Dart Aerospace Ltd.

Customer : CU-DAR001 Dart Helicopters Services Drawing Name : SHROUD AIRFLOW HEATER SYSTEM
 Job Number : 35113
 Estimate Number : 12345
 P.O. Number : N/A Part Number : D206746011
 This Issue : 10/11/2007 S.O. No. : N/A Drawing Number : N/A
 Prsht Rev. : NC Project Number : N/A
 First Issue : N/A Type : SMALL /MED FAB Drawing Revision : N/A
 Previous Run : 34053 Material : N/A
 Due Date : 10/26/2007 Qty: 1 Um: Each
 Written By :
 Checked & Approved By : 07.10.11
 Comment : est rev.A 06.03.23 new issue EC
 est rev.B 06.04.26 updated pick list EC
 Est Rev:C 06-05-24 Per Rev A JLM

DART SERVICE INSTRUCTION

TO AMEND INSTALLATION INSTRUCTIONS IIN-D206-746 REV.A

D206-746-043 BLOWER MOTOR ASSEMBLY

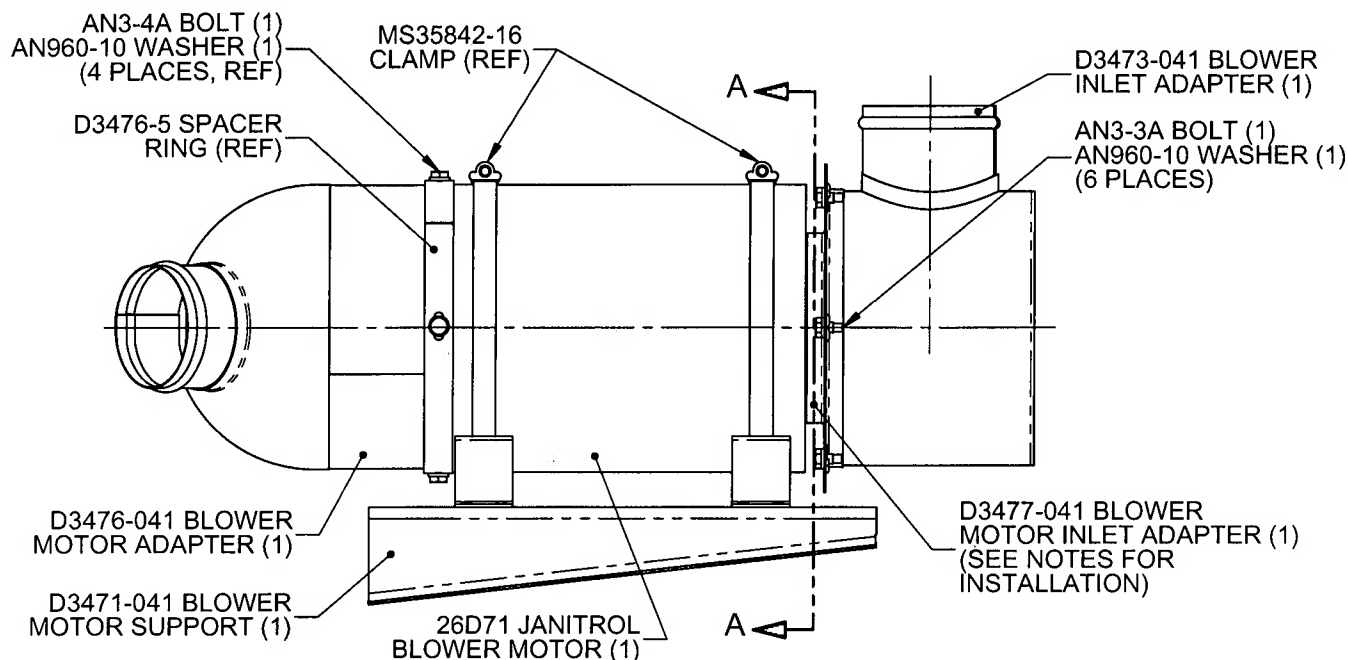
The Parts List of Installation Instructions IIN-D206-746 Rev. A should be amended as follows:

Furthermore, any mention of "Blower Motor Assembly" appearing in Installation Instructions IIN-D206-746 Rev. A, and Installation Drawing D206-746 Rev. A, should be replaced by D206-746-043 Blower Motor Assembly.

Qty -011	Qty -041	Qty - 043	Part Number	Description
X			D206-746-011	SHROUD AIRFLOW HEATER SYSTEM
1	X		D206-746-041	REAR OVERHEAD PASSENGER MODIFICATION KIT
1		X	D206-746-043	BLOWER MOTOR ASSEMBLY
		1	D3471-041	BLOWER MOTOR SUPPORT (CAM-1984-008)
		1	D3473-041	BLOWER INLET ADAPTER (CAM-1984-013)
		1	D3476-041	BLOWER MOTOR ADAPTER (CAM-1984-014)
		1	D3477-041	BLOWER MOTOR INLET ADAPTER (CAM-1984-015)
<i>B</i>		2	D3585-1	SET SCREW
<i>B</i>		A/R	26221	LOCTITE 226 THREADLOCKER
		1	26D71	BLOWER MOTOR (26D71-1)
		6	AN3-3A	BOLT
		6	AN960-10	WASHER
		3	MS27039-08-04	MACHINE SCREW
		3	MS35333-38	LOCK WASHER
<i>B</i>		A/R	MS20995-025E	LOCK WIRE

DETAIL B
SCALE 1:1

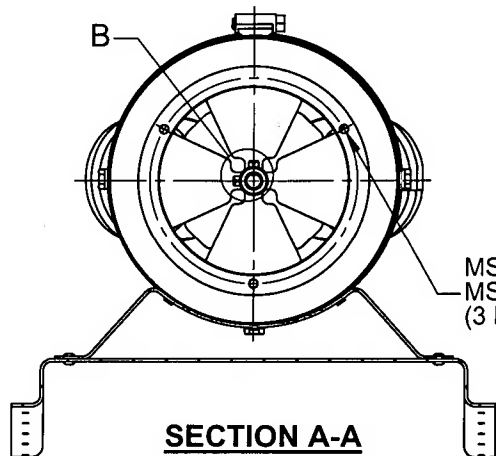
REPLACE EXISTING SET SCREWS
WITH D3585-1 SET SCREWS (2),
APPLY LOCTITE 226, TORQUE TO
50-70 in-lbs (5.6-7.9 N-m) AND SECURE
USING MS20995-025E LOCK WIRE
